TECHNICAL MEMO

Geotronics AB, Technical Support Dept., Danderyd, SWEDEN, September 1997

TI/9702A

- Level:** 3.
- Instrument type:** Geodimeter system 600.
- Subject:** Vertical servo not working.
- Description:** The vertical servo function on the SRV and SRV2 boards can break due to ESD through the vertical servo knob. Replace IC46 and IC49 on the SRV/SRV2 boards to LM6482 RAIL-RAIL OP X2.
- IC46, IC49 LM6482 RAIL-RAIL OP X2 Part no: 571 804 246
- Mark the SRV board with rev. D02/08 and SRV2 board with rev. D00/04.
- Perform this modification if the vertical servo is not working.

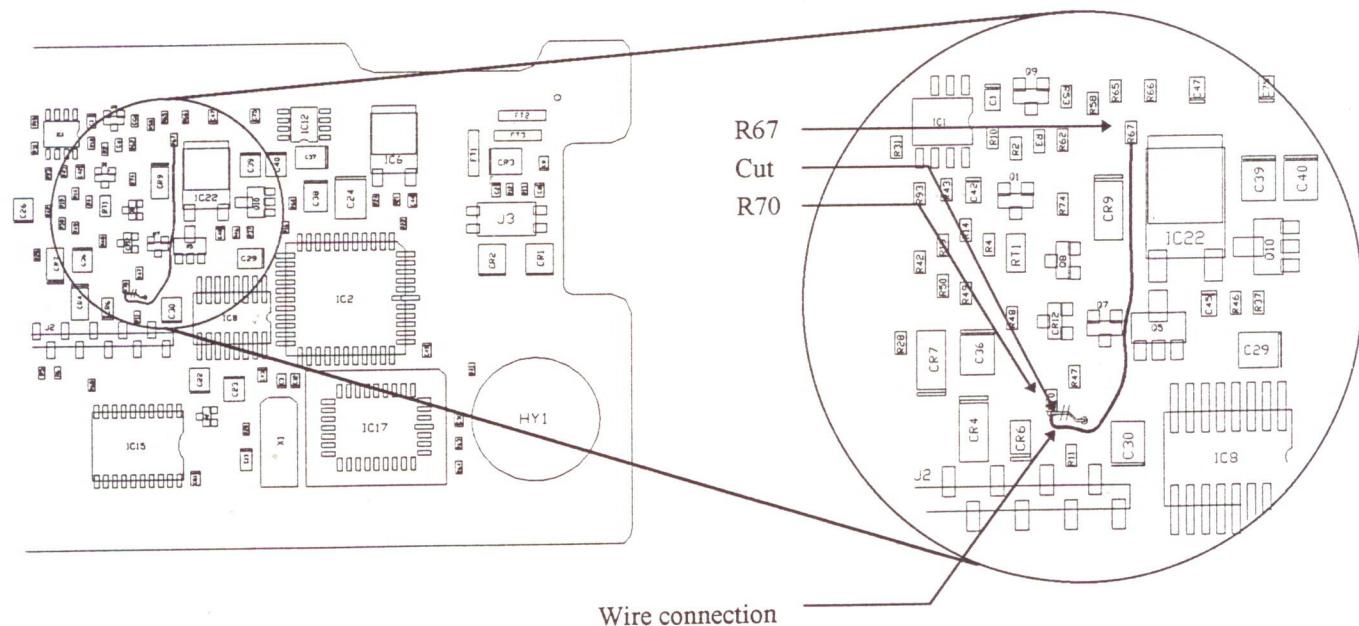
Description: MEM and MEM-M board could not read PCMCIA cards of other types than SunDisk 1,8 and 5,2 Mb.

The reset pull-up pin was connected to GND instead of VCC.

Changes rev. C00 → C01:

The reset card signal will be connected to VCC via 100 kohm (R70) instead of GND.

- Change R70 to 100 kohm part number 571 806 501.
- Solder a wire between R70 and R67.
- Cut connection from R70 to GND.

Fig. 1, opening of control unit.

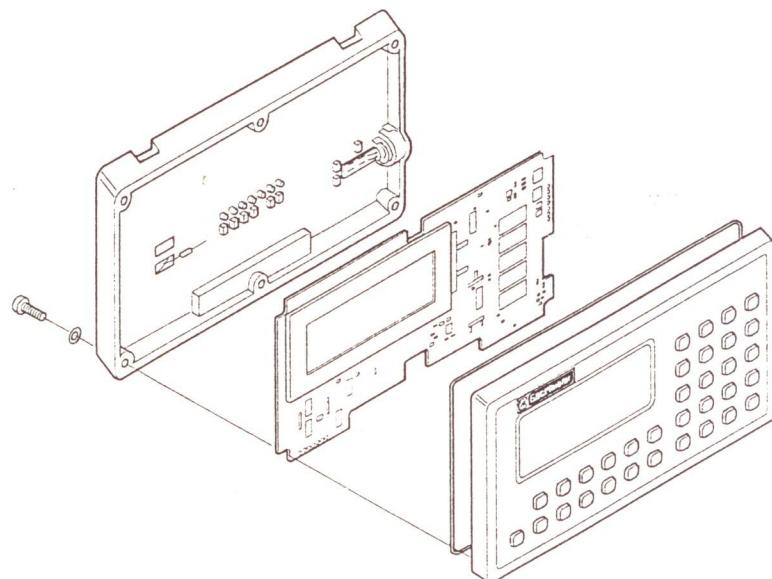
1. When mounting the backup battery, the connecting pins soldered to the MAP board can break due to mechanical stress. The breaking point (cracks) might almost be invisible.
2. To eliminate theses infos and to improve the batt. low function perform this modification. Mark the MAP board with rev D03.

- Remedy:
1. Open the control unit (*Fig. 1*).
 2. Resolder the "crack" on the battery connecting pins (*Fig. 2 and 3*).
 3. - Replace R12 from $1 \text{ M}\Omega$ to $470 \text{ k}\Omega$ (*Fig. 4*). Part nr. 571 806 517
 - Replace R93 from $47 \text{ k}\Omega$ to $4.7 \text{ k}\Omega$ (*Fig. 4*). Part nr. 571 806 317
 - Remove pin 4, IC30 from the pad and connect to pin 5, IC30 (*Fig. 4*).

Fig. 1 Cover for bearing plate.

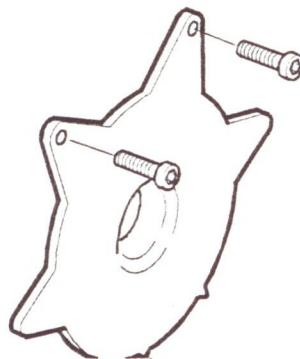
Description: The cover for the bearing plate is mounted with two screws at the top (*Fig. 1*). Therefore there is a possibility that the cover for the bearing plate will make contact with the batteries and cause memory loss of the PVX/PVX2 board.

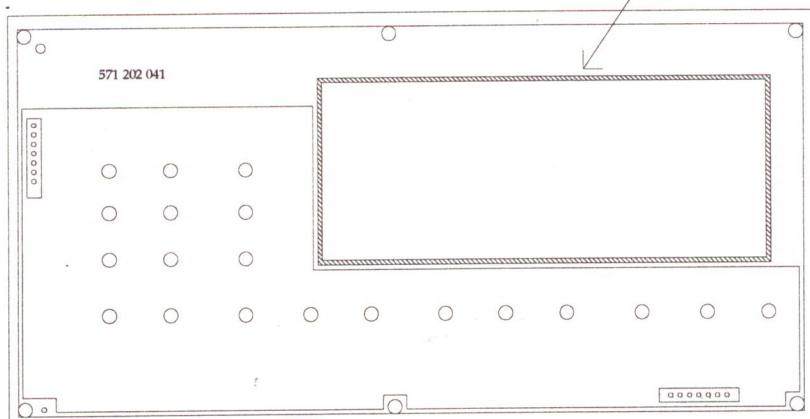
Description: Occasionally moisture has been detected inside the front glass. To prevent this, apply Silicon glue on the inside of the front cover according to the description below.
Silicon glue Wacker A07, part no: **571 904 134**.
Disassemble the CU unit and remove the MAP board. Apply Silicon on the inside of the front cover towards the display glass.
This operation should be performed at first possible service occasion, on all CU units.

Apply Silicon glue Wacker A07 —————

~~~~~ = Glued area.

RAC board in the radio side cover:

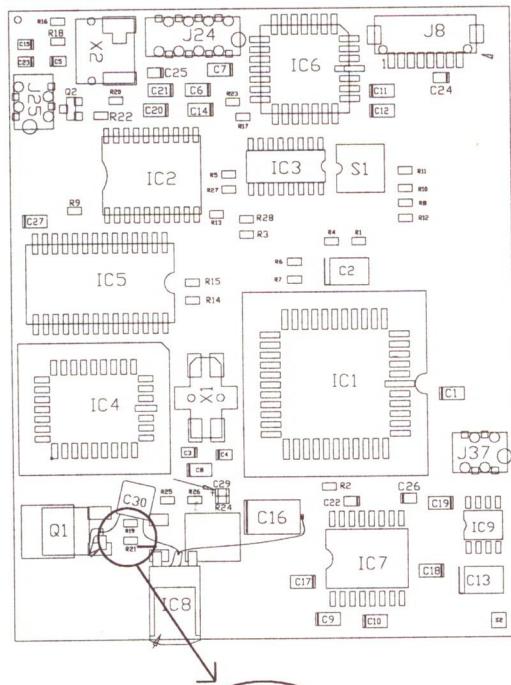
**Description:** Remove R21 on the RAC board to prevent discharge of batteries.  
Revision of the RAC board is unchanged C02.  
Perform this modification at the next service occasion.

### **Picture 1:**

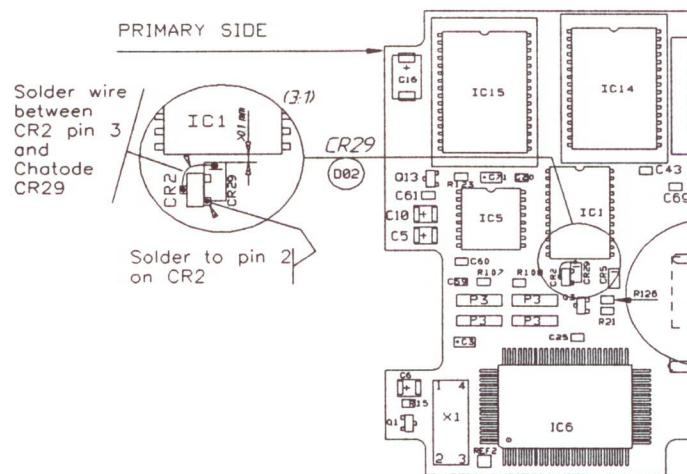
Install: **CR29** Bat 48 Ref.no: 571 803 010. The anode of CR29 shall be soldered directly onto CR2 pin 2, and the cathode ( marked with a ring ) shall be connected with a wire to CR2 pin 3 as shown in picture 1.

**Note !** When soldering the wire to the cathode of CR29, put a piece of paper between IC1 and the soldering point to prevent short circuit to the substrate pin sticking out in the middle of the short side of IC 1.

### Picture 2:

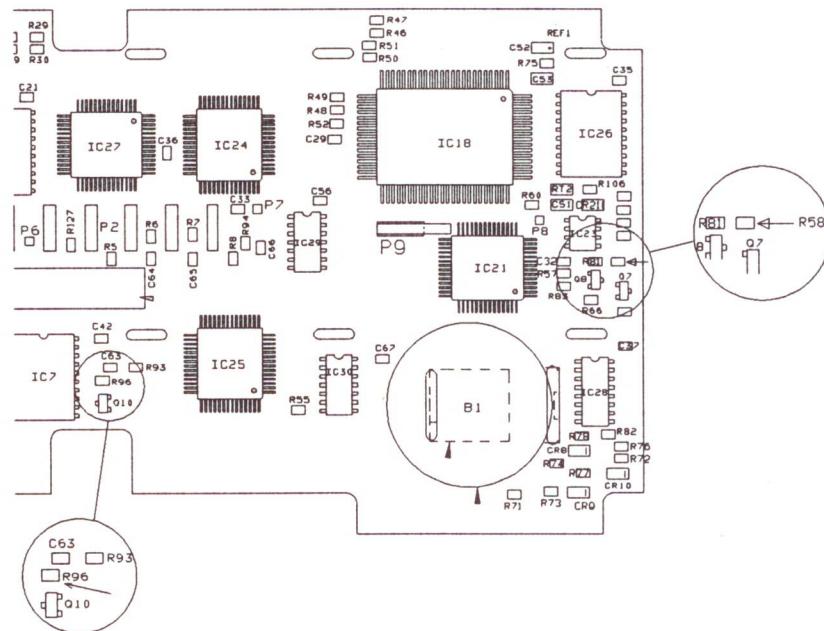
Change the following resistors: **R 58** from 4.7 kohm to 3.3 kohm Ref.no: 571 806 313.

**R 96** from 100 kohm to 220 kohm Ref.no: 571 806 509.  
Shown in picture 2.

### **Picture 3:**

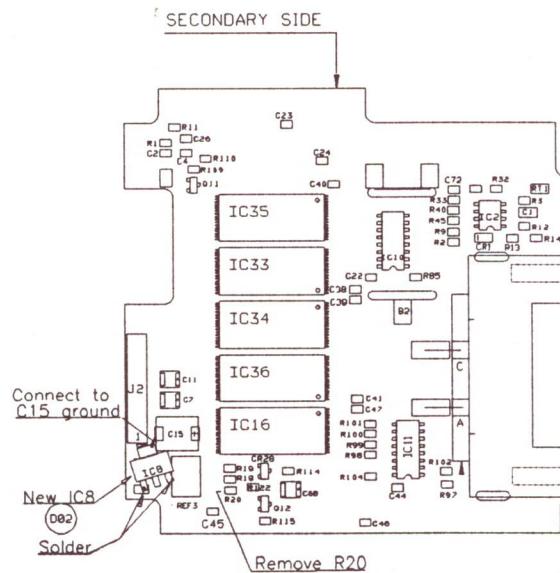
Remove the following resistor: **R 20** 4.7 kohm  
Shown in picture 3.

The LT 1129-5 shall be rotated 1/3 of a revolution ccw in relation to the old IC8. Connect IC8 pin 2 ( cooling flange ) to ground on C15, as shown in picture 3.

## PWS2/PWS2R, primary (lower right) component side.

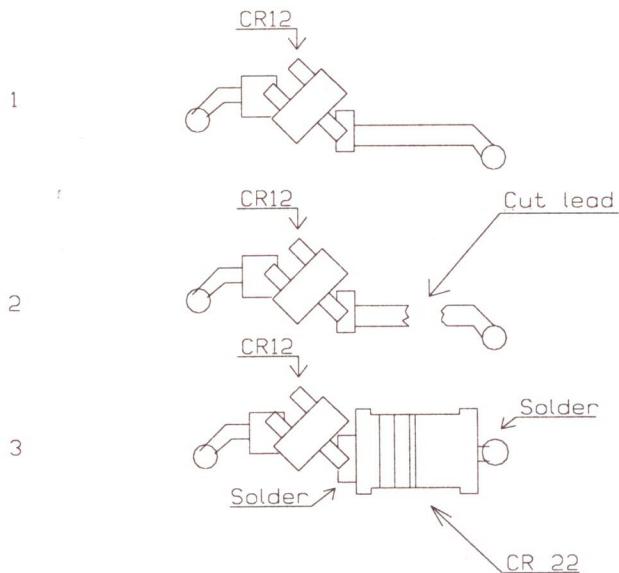
**Description:** Difficulties starting the instrument, from the GDM keyboard or from the RPU unit, depending on batch variations of the IC9.

**Remedy:** Cut lead and add the diode CR22 (TMM, BAT 48)  
part no: 571 803 010 between IC9 pin 5 and CR12 pin 3.  
\* Change PWS2 rev from B07 → B08.  
\* Change PWS2R rev from A04 → A05  
**Note orientation.** See figure.

## PWS2/PWS2R, primary (lower right) component side.

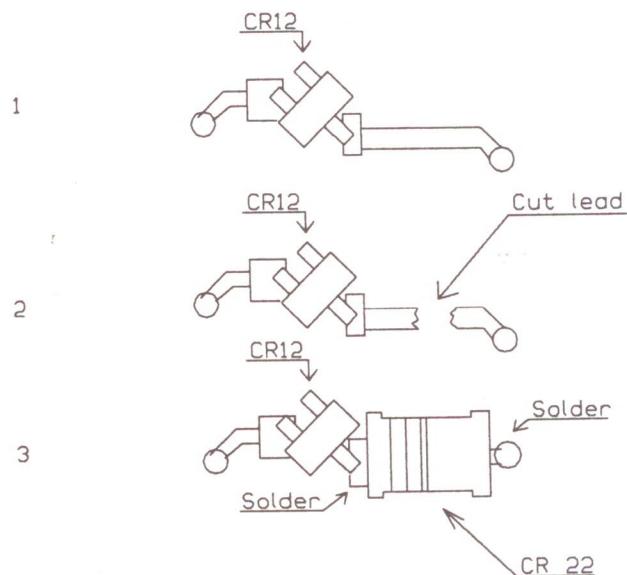
Difficulties starting the instrument, from the GDM keyboard or from the RPU unit, depending on batch variations of the IC9.

Cut lead and add the diode CR22 (TMM, BAT 48)  
part no: 571 803 010 between IC9 pin 5 and CR12 pin 3.

**Note orientation.**

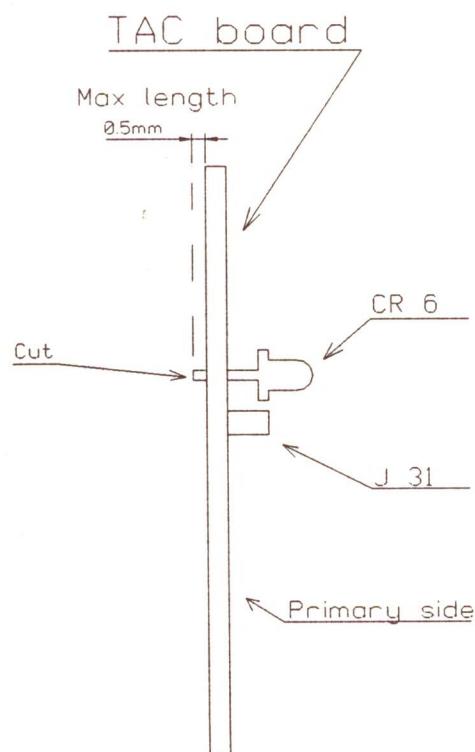
Description: Prevent risk of shortcircuiting between CR6 and the Trackerunit

Remedy: Cut pins on CR 6 to a max. length of 0.5mm, on the secondary side. See figure.

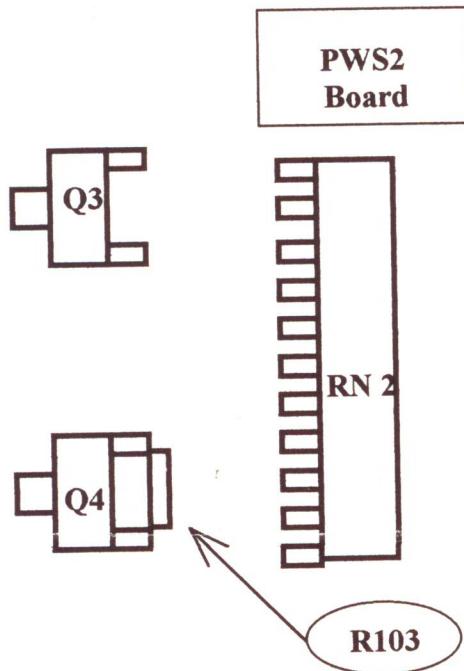
Description: When the RPU sends the "On" command to the GDM  
a spike can appear on the PWS2 board and turn the radio  
in the GDM off.

Remedy: Solder a resistor **R103** (4.7k ohm) part no: **571 806 317** between  
pins on **Q4** on the **PWS2** board, see figure. Mark the board, rev "B07"

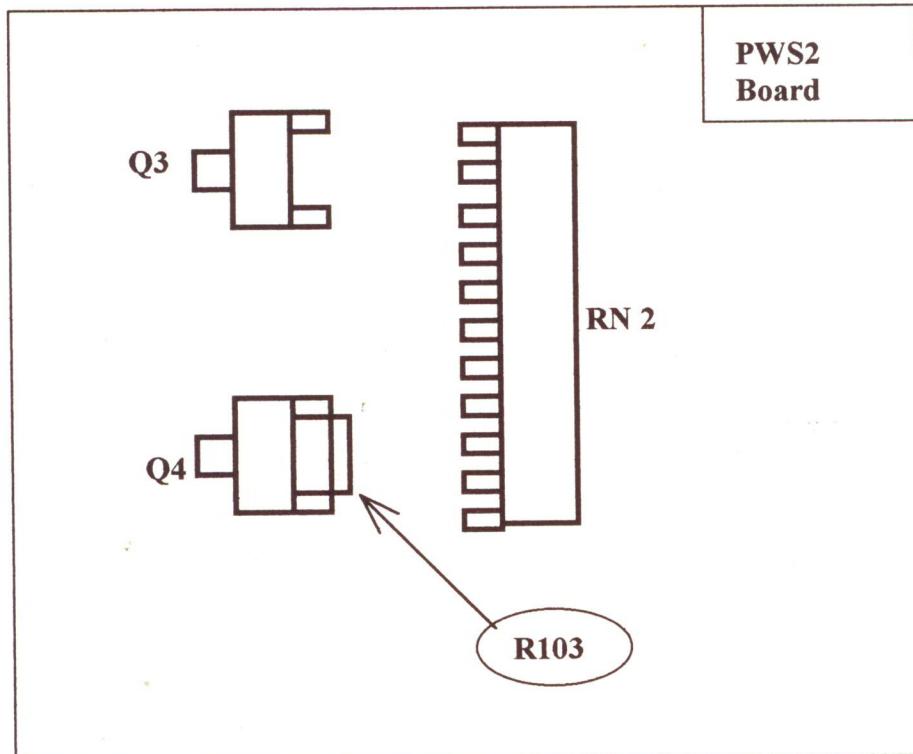
Description: When the RPU sends the "On" command to the GDM a spike can appear on the PWS2 board and turn the radio in the GDM off.

Remedy: Solder a resistor R103 part no: 571 806 317 between pins on Q4 on the PWS2 board, see figure.

PVX - Board, whiteout protection.

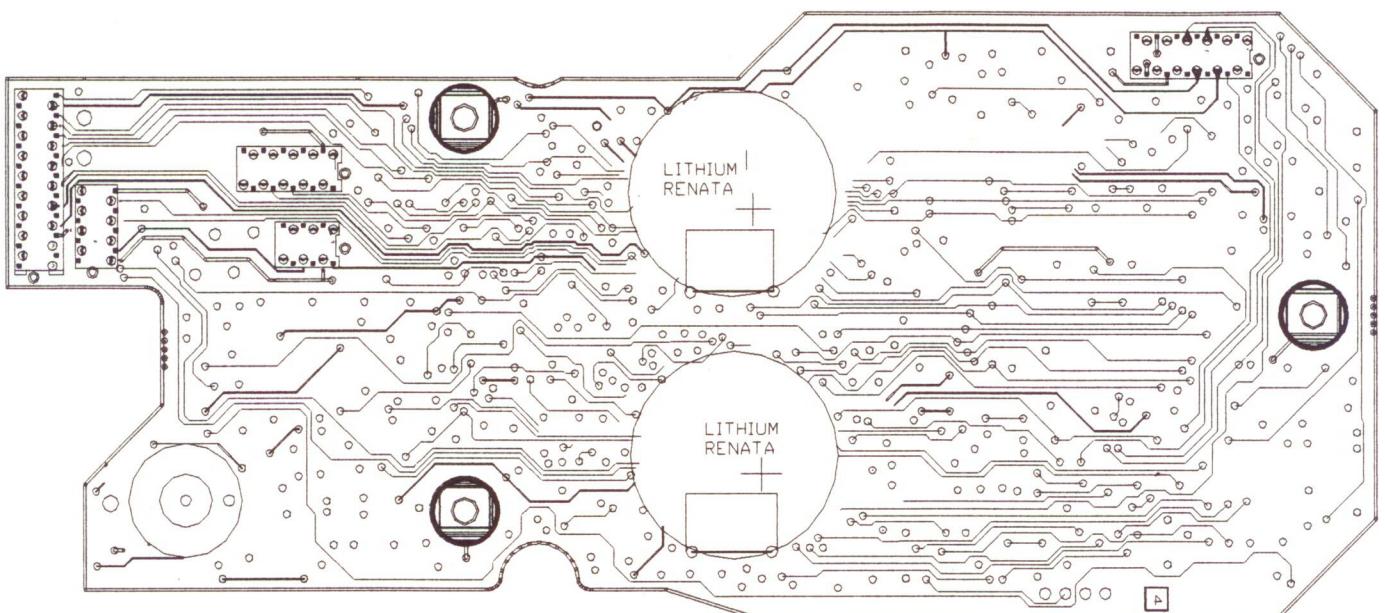
Description: To prevent ESD on the PVX board caused by the grounding cable, connected between the yoke and the alidad.

Remedy: Place a piece of non chargeable insulation protection, part no: 571 200 528 on the PVX board as shown on next page, fix with pliobond on the top PVX screw.

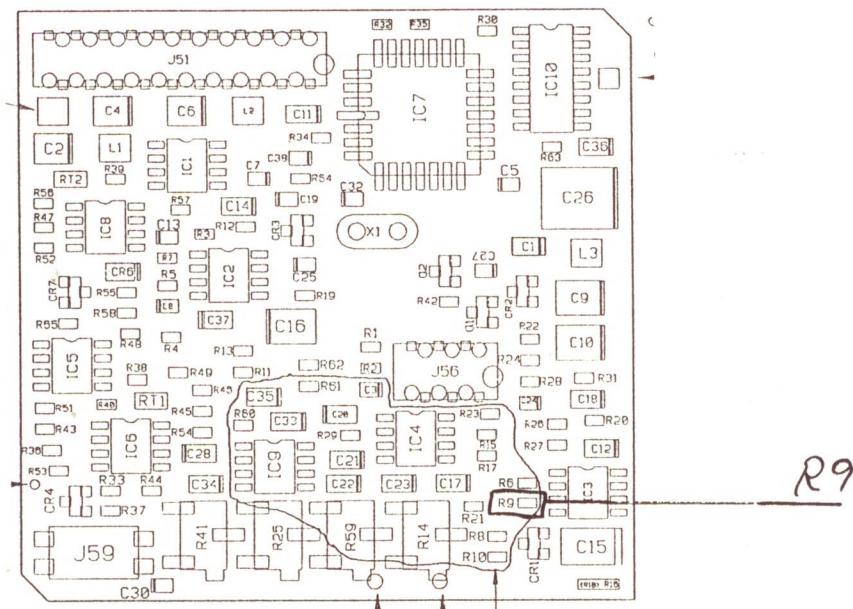
**Description:** "G" in display or random distance readings due to high sensitivity to dampness,

- Remedy:** 1) Replace resistor R9, 10.0 Kohm to 1.0 Kohm  
2) Verify action by making a dampness test.

Mark the board Rev.D06

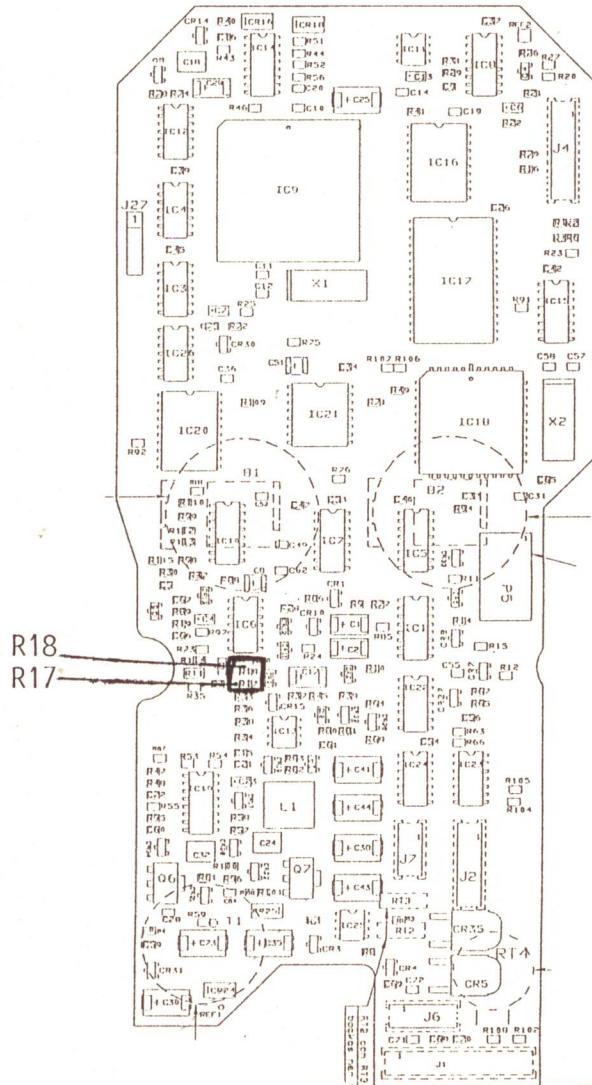
**Description:** Unreliable Switch Off function;

**Remedy:** Replace R17, 10,0 Kohm to 47,0 Kohm => Part no: 571 806 417  
 Replace R18, 1,0 Kohm to 4,7 Kohm => Part no: 571 806 317

Mark the board Rev. D00/04

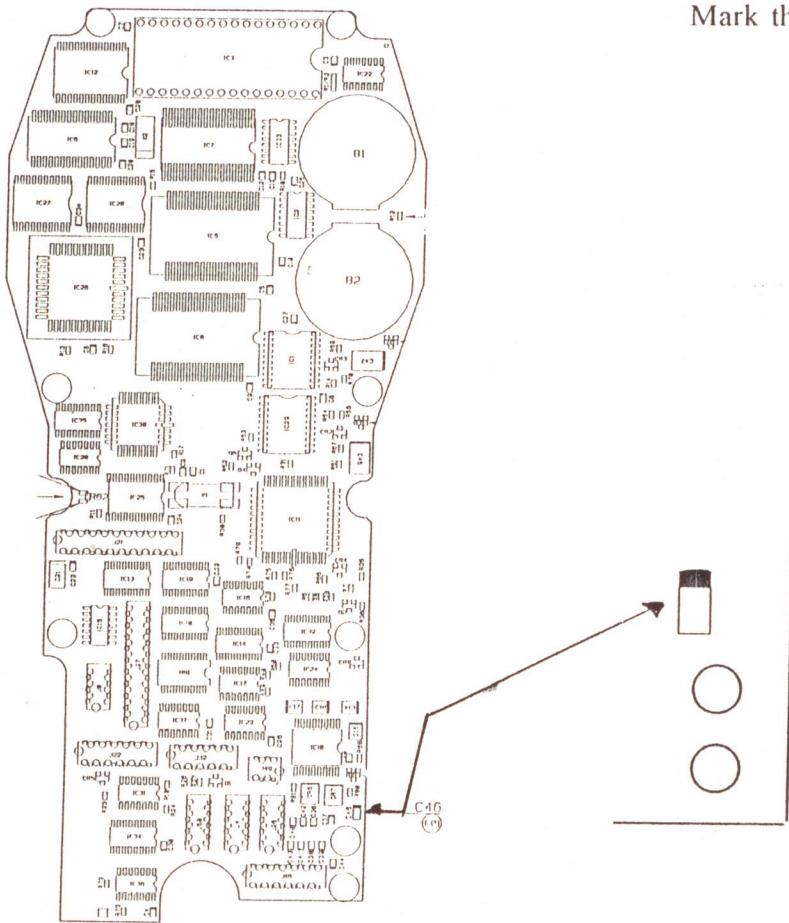
**Description:** Malfunctioning RS-232 communication ;

**Remedy:** Capacitor C46, (1.0  $\mu$ F, 16V ) polarized, must be positioned as specified.

Verify position of polarity => see fig. below.

Replace capacitor when faulty connection found !      Part no: 571 802 101

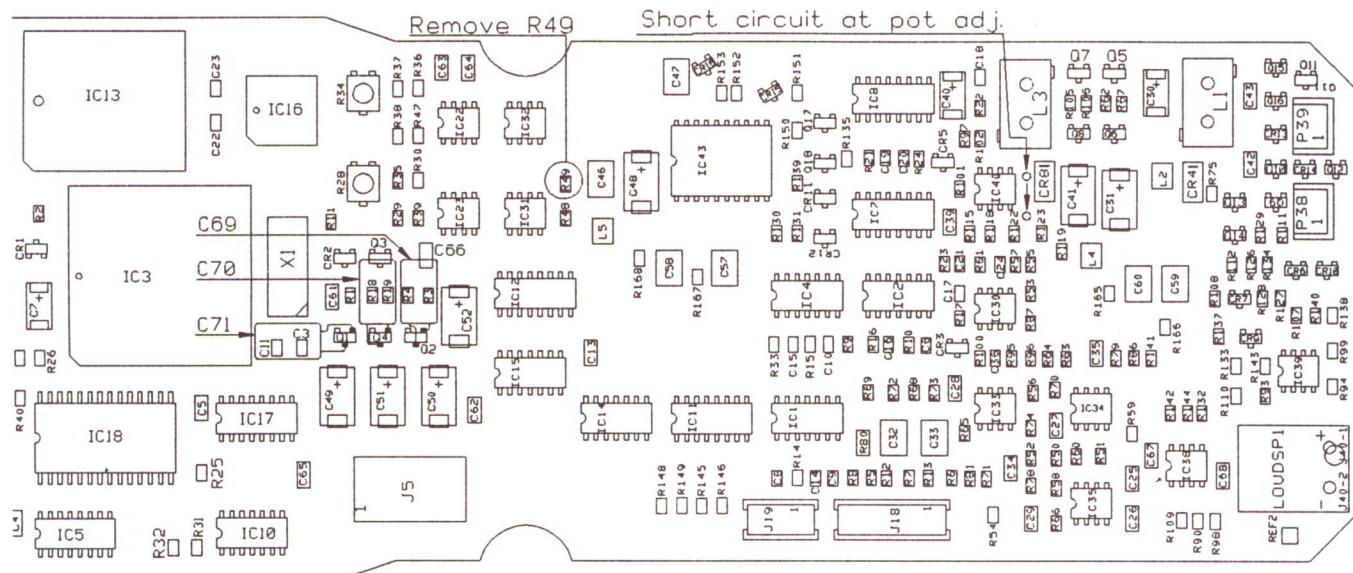
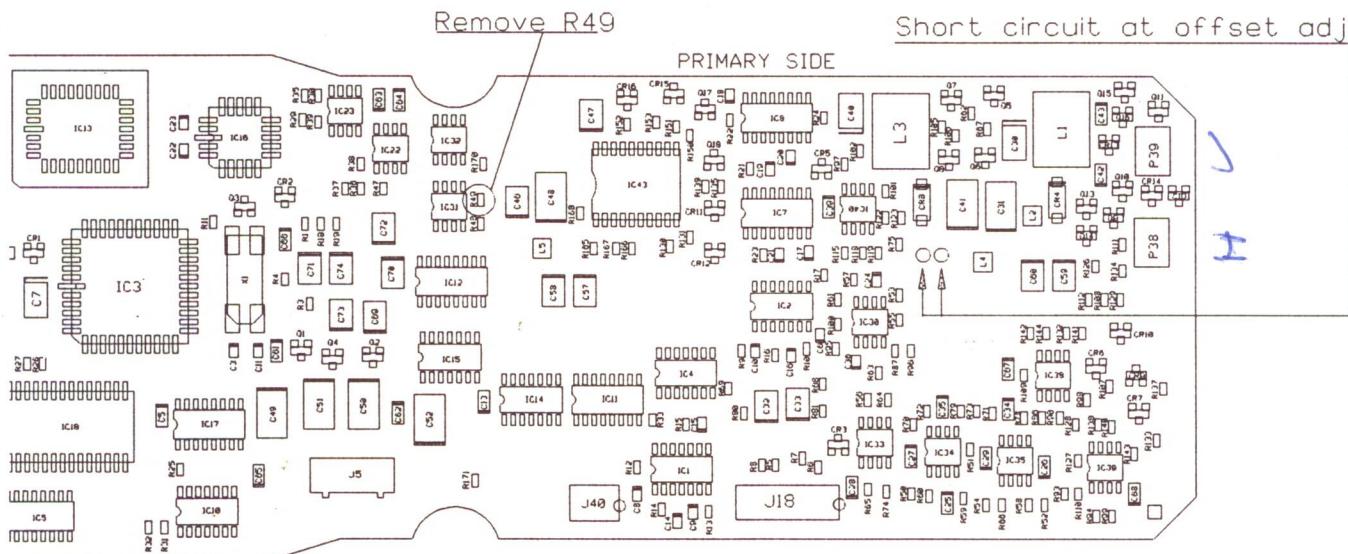
Description: Calibration values for the servos can be "randomised" when the instrument is switched off/on => resulting in erratic positioning. Positioning diff. 0-66°, => an error of 0-9 mm / 100m.

- 1) Replace the PROM ( IC13 ) to valid revision;  
Always use special tool to take the prom out of the socket!
- 2) Remove resistor R49 => see diagram;
- 3) Perform a calibration of the servos, see SST program.

Mark the board rev D00/05  
(No change on the rev C board)
